**Addendum Number Two**  
To The Drawings and Specifications for  
**SEDGWICK COUNTY – Waiting Room Addition**

Issued: Thursday, August 20, 2020

You are hereby instructed to include in your bids the following changes and/or corrections to the Drawings and Specifications for the **Waiting Room Addition to the Sedgwick County Corrections building located at 622 East Central.**

SHEET  
SP1.1

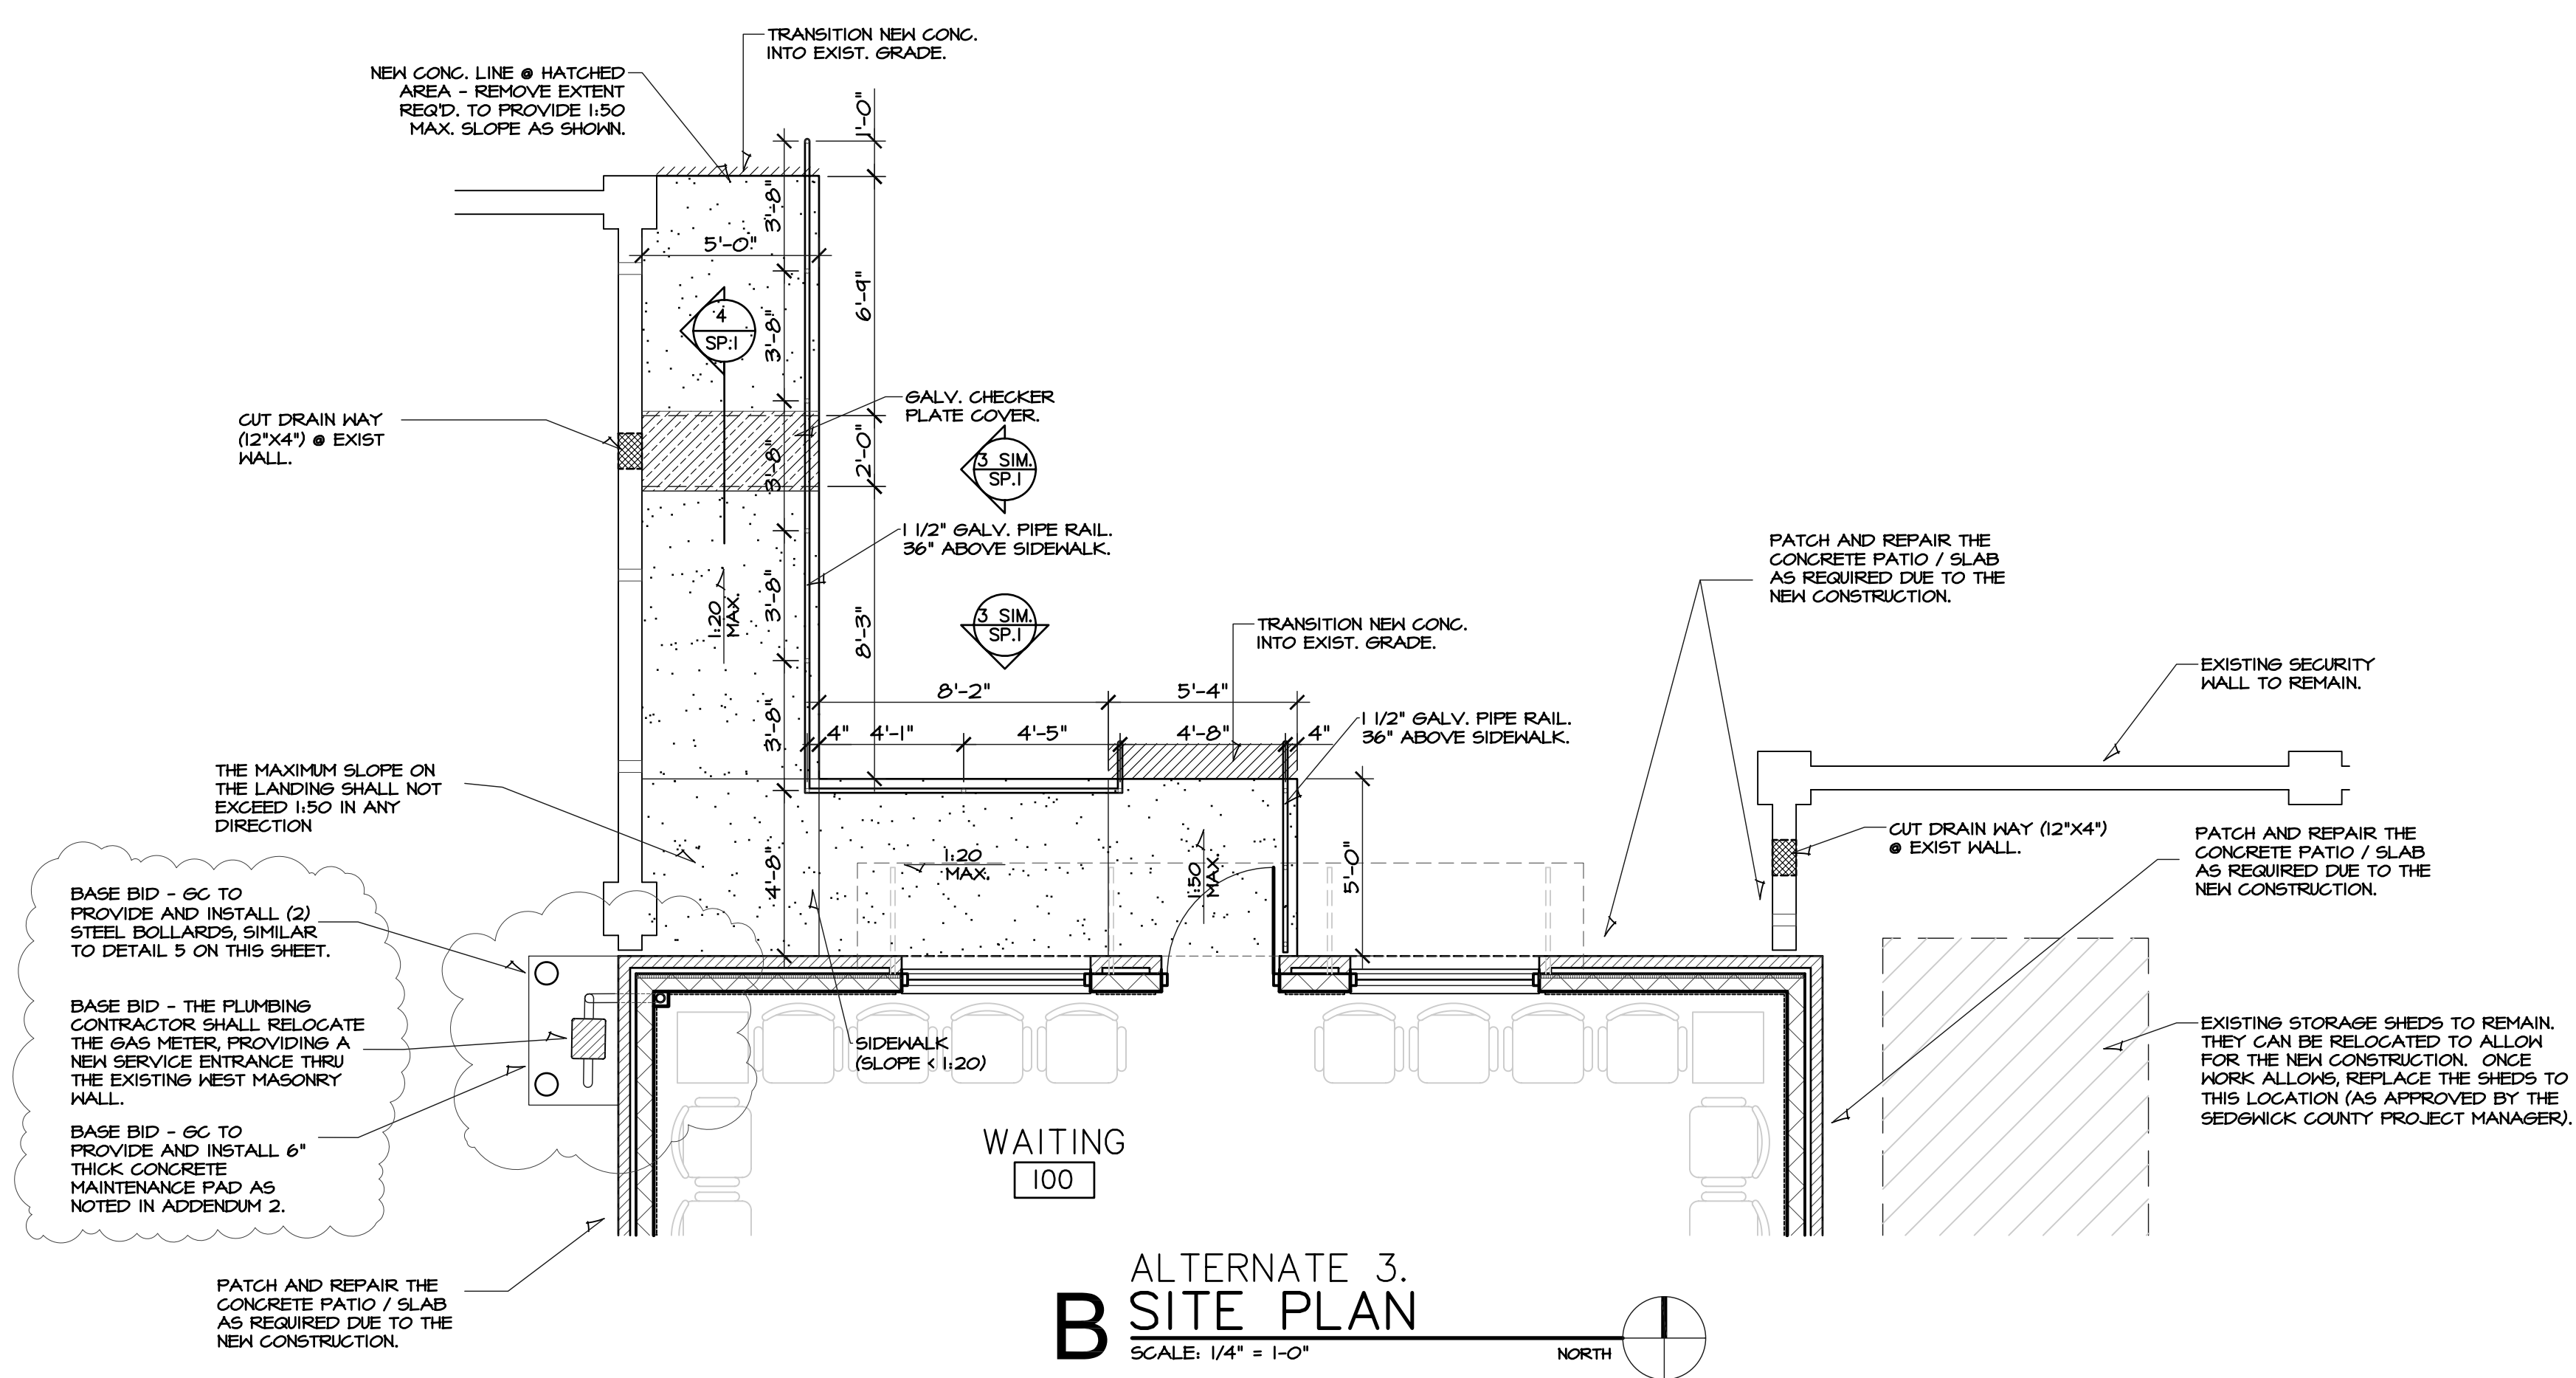
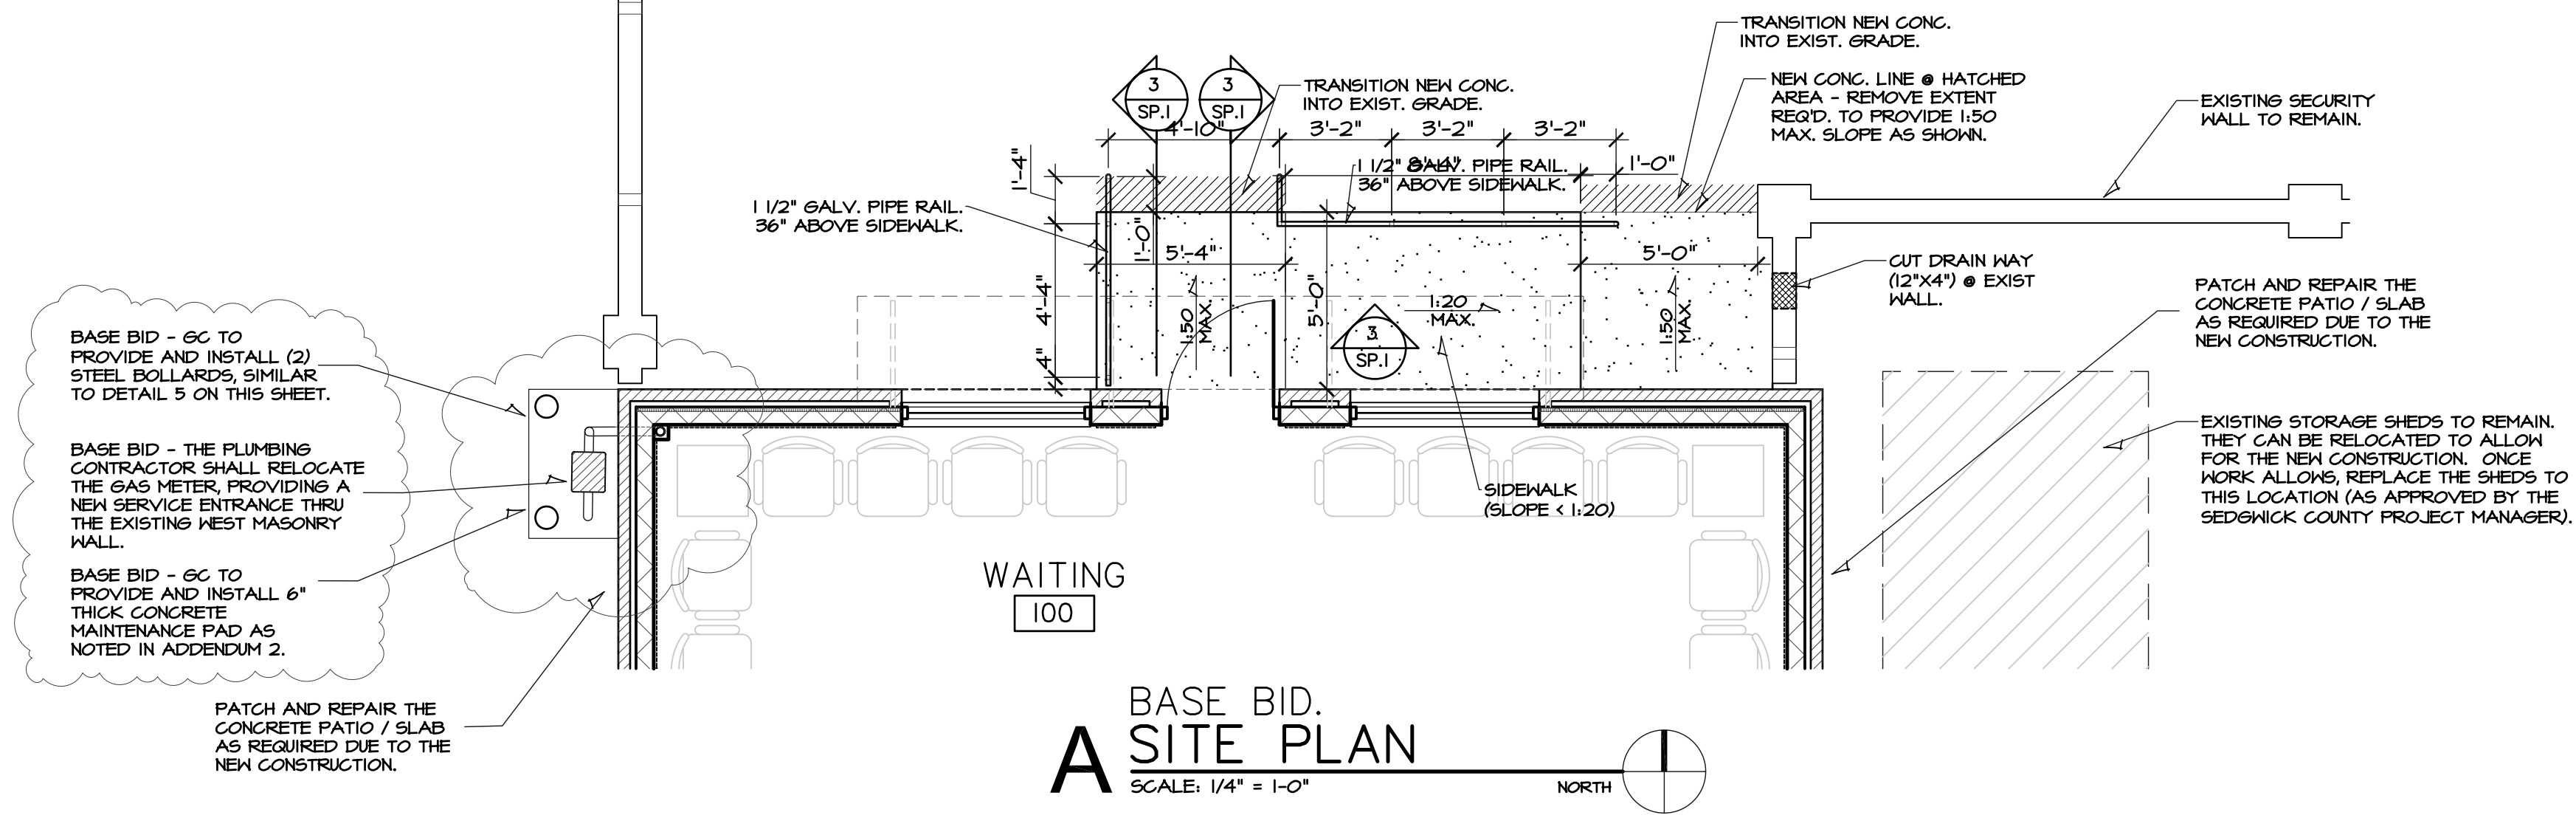
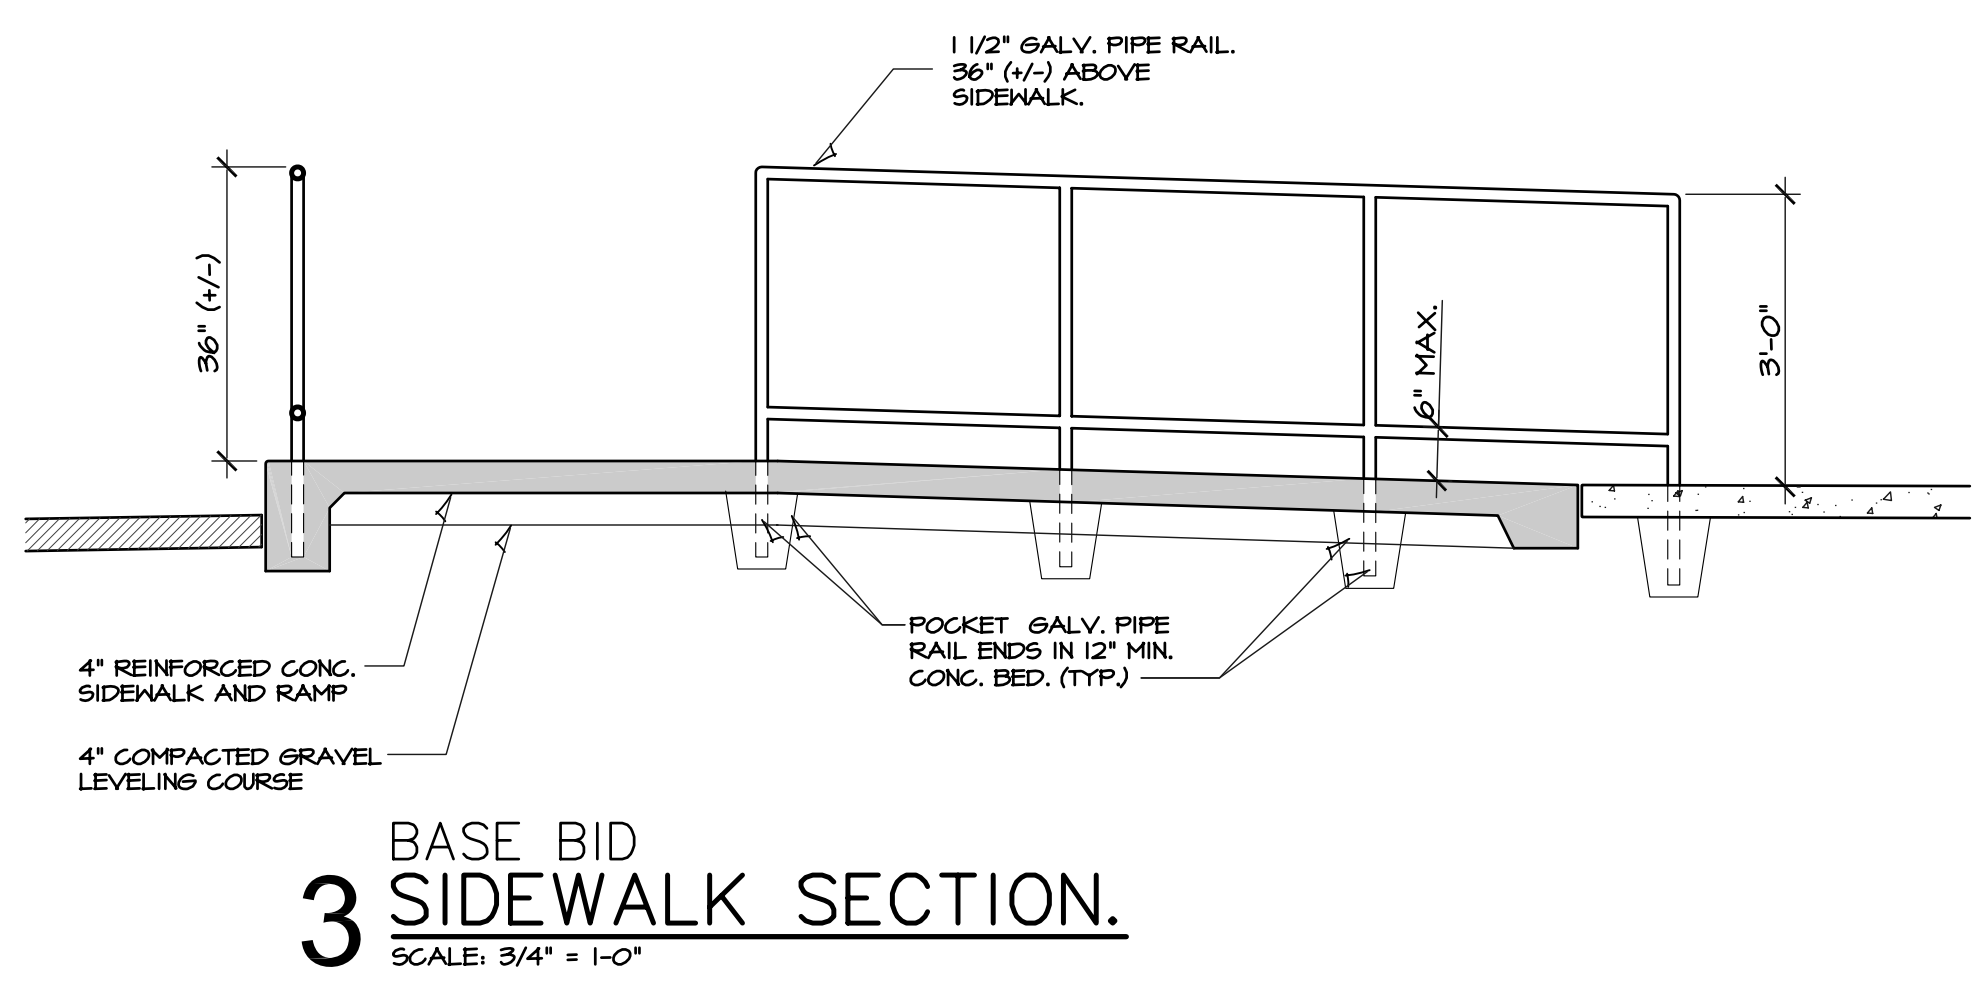
### 3.1 Sheet SP1.1

This sheet has been revised to show the new gas meter location. This sheet is reissued with this addendum.

- a. The Gas Meter shall be relocated to the West side of the existing building (in the parking lot). This will allow for the reconnection of the gas service prior to construction of the addition.

- b. The General Contractor shall pour pad on top of the existing paving for the gas meter and bollards to sit on. The pad shall be 4' square x a 6" thick concrete, reinforced with one layer of 6 x 6-W2.0 x W2.0 W.W.F. and #4 "L" bars at 24" o.c. drilled into the existing paving around the perimeter. The "L" bars shall be 12"x12".

- c. The General Contractor shall provide and install (2) 4" diameter steel bollards per the detail that is included with this addendum. The bollards shall be filled with concrete creating a domed top. The bollards shall be painted "safety yellow".
